**Issue 3**

**Are the strategic objectives and the strategic approach to housing delivery and economic development delivery in terms of distribution and location sound having regard to the needs and demands of the Borough, national policy and Government objectives and the evidence base and preparatory processes? Has the Local Plan been positively prepared?**

**Subject:**FW: 15/00856/AS - Land at Pound Lane, Magpie Hall Road, Bond Lane and, Ashford Road, Kingsnorth, Kent

**Application - 15/00856/AS**

Figure 1 - Crash (accident data study area)

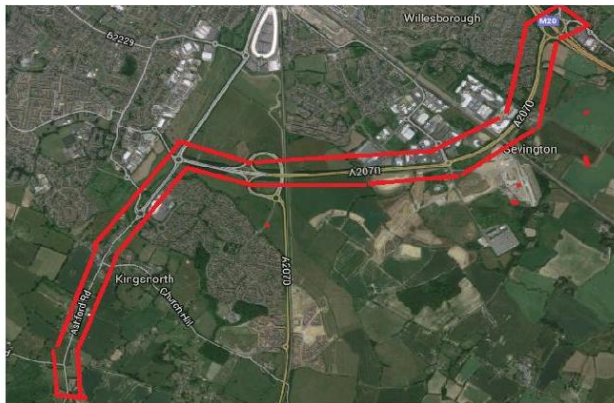
Crash data needs to be obtained for a wider study area than what is currently shown. As detailed in KCC Highways and Transportation previous consultation response on the application, the extent of crash data should be provided as shown in Figure 1 below. This is from the junction of Magpie Hall Road / Ashford Road / Steeds Lane to the junction of M20 Junction 10. Dialogue should also be undertaken with Highways England in respect of the Strategic Road Network. A section is needed within any amended supplementary Transport Assessment detailing any particular crash clusters (for example the junction of Magpie Hall Road / Ashford Road / Steeds Lane and Pound Lane / Church Hill / Ashford Road).

The Bellamy Gurner Junction to replace the orbital roundabout on the A2070

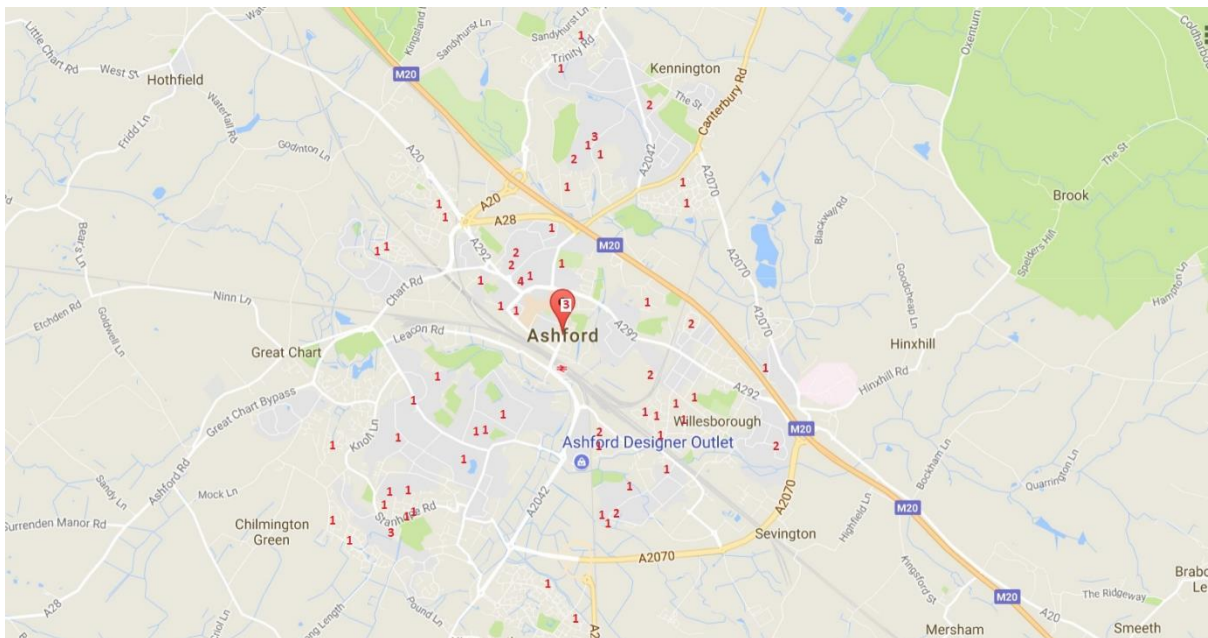
- 3.18 The Bellamy Gurner junction scheme is not included in IDS and should be added due to its scale and significance. The constraint imposed by modified condition 32 should also be acknowledged at Finberry, whilst a minimum of 500 homes are allowed further development will not be permitted once the site generates 301 movements in the peak hour until the full Bellamy Gurner scheme is implemented.
